## AMERICAN INTERIORS JSP16-55

Consideration at the request of American Interiors, for approval of Preliminary Site Plan, landbank parking and Storm water Management Plan. The subject property is located in Section 4 of the City of Novi north of West Road and east of Hudson Drive. The applicant is proposing to construct a 21,437 square feet single story office and warehouse building of consisting of office and warehouse space and associated site improvements. The applicant is proposing to landbank up to 17 spaces of the required 66 parking spaces.

Approval/Denial of the Preliminary Site Plan, landbank parking and Stormwater Management Plan.

**SITE PLAN**

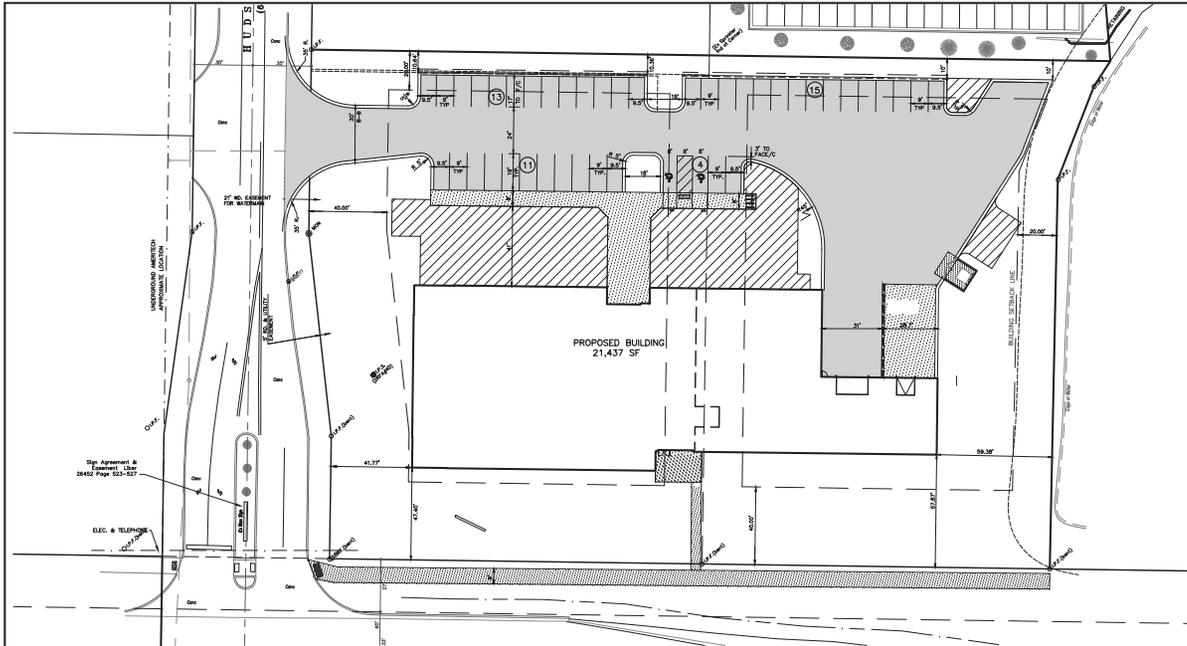
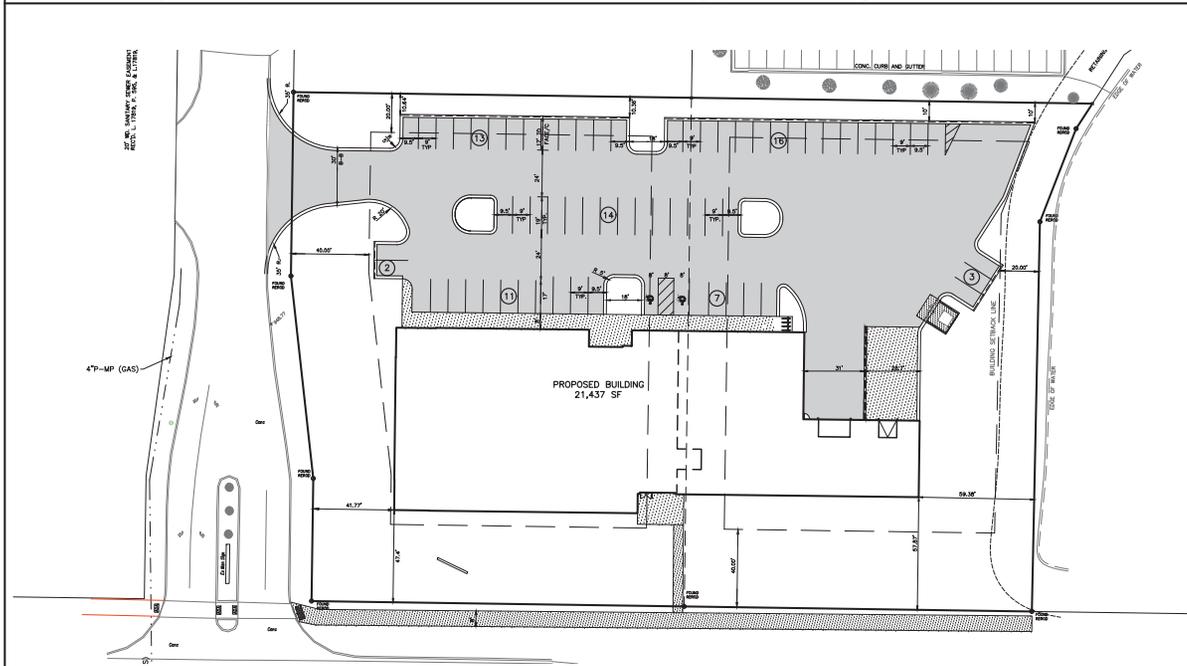
1. Landbank parking: The site plan as proposed would require 66 parking spaces. The applicant is proposing 43 spaces with the current plan land banking 23 spaces to be built when the business expands or if a need is identified. Per code, **only 25 percent of required parking can be landbanked, which is up to 17 spaces. Please revise the plans to meet the requirement or a Zoning Board of Appeals variance is required for the deviation.**

- c. Two of the 43 proposed parking spaces will be barrier free parking spaces.
  - d. The "Expanded Parking Layout" on sheet 3 shows a row of 16 spaces on the north side of the site. Per City Standards, Section 5.5.3.C.ii.i, there should be a parking island after every 15 spaces.

- a. At the time of Final Site Plan submittal, the applicant shall revise the site layout according the alternate provided via email to limit the landbank parking to twenty-five percent of total required at the time of Final Site Plan;

**ALTERNATE SITE PLAN TO KEEP LANDBANK PARKING SPACES UNDER 25 PERCENT**  
Shared by applicant via email dated 11-09-2016

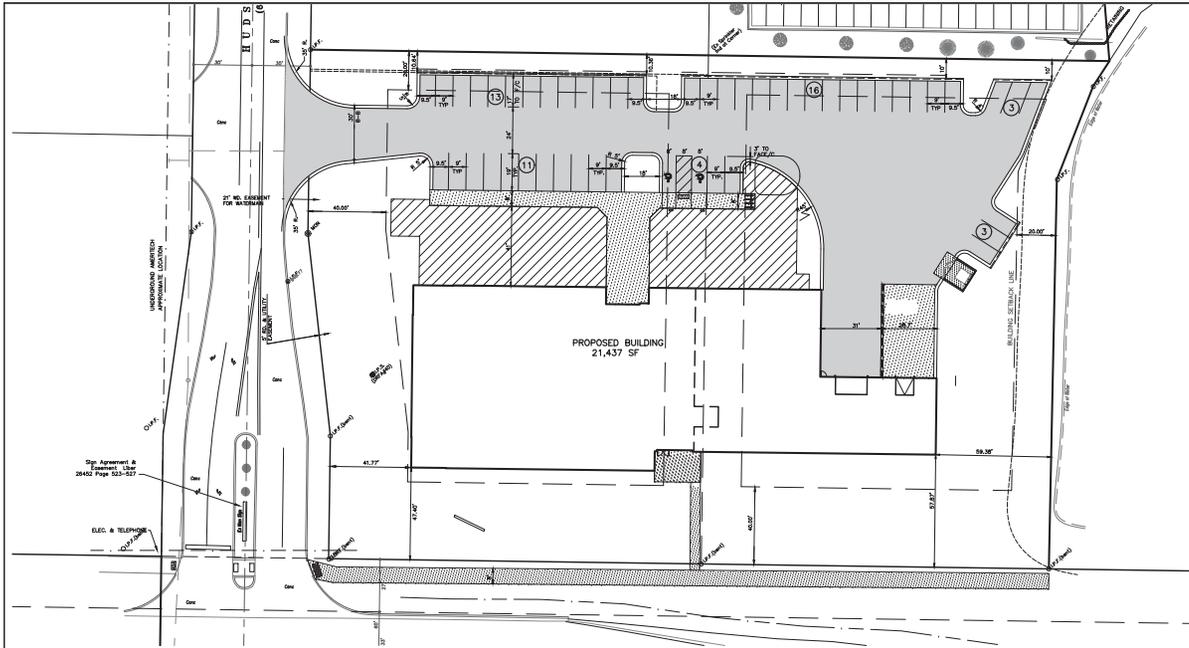
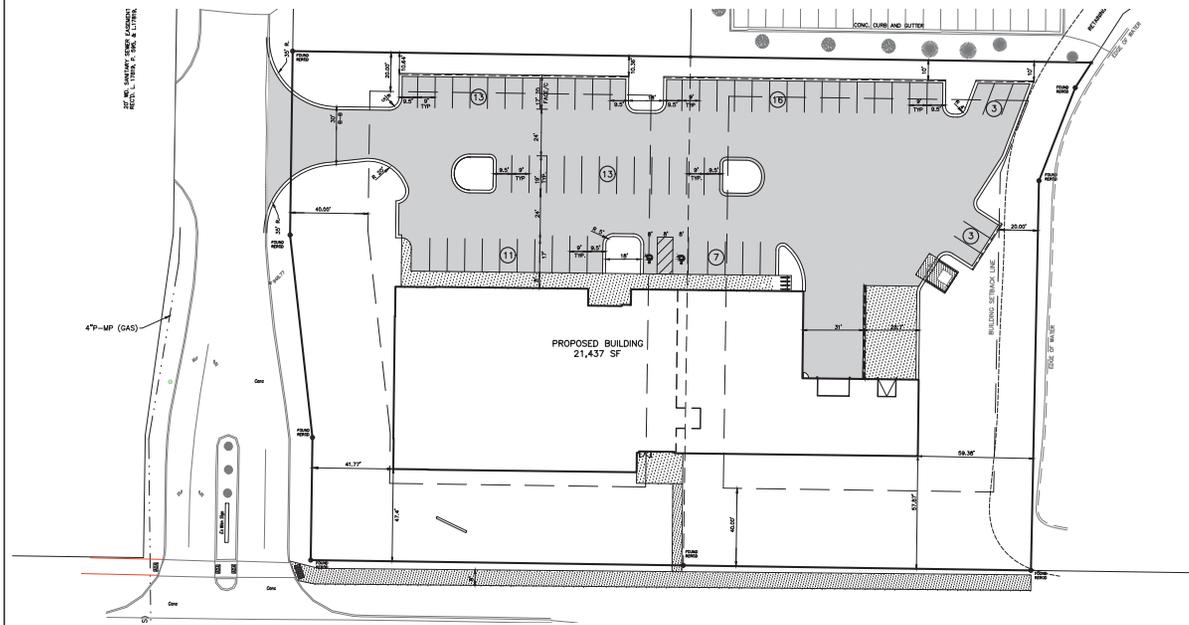
- minimum number of spaces required prior to request for land banking: 45 spaces	Minimum required spaces: 66 Spaces	Yes	
	- Alternative layout plan showing land bank parking	An alternate plan is submitted	Yes	<b>The plan needs to be revised to meet the minimum 25% requirements</b>
